Access Compliance Report

Public Rights-of-Way

(Pedestrian Signals)

Intersection ID: N/A	Main Street:	Cross Street: N/A	Location: N/A
ADA ID: 22A6BC96F8E9	Signal Type: One Push Button-Non APS	Overall Compliance: No	Severity Score: BTN 1: N/A BTN 2: N/A No BTN: N/A
Codes/Mitigation Info/Possible Solution		Field Measurements/Component Compliance

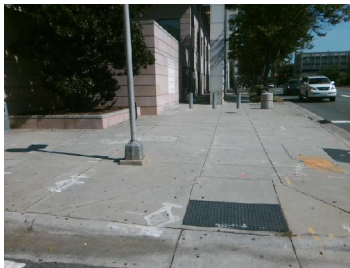
PROW/ADA: TMUTCD 4e.08, R404.3, R406.2, DMS-11132, R104.2, R209.1

Possible Solutions: Replace Signal Push Button With APS Button on New Post. Remove & Relocate Sign.
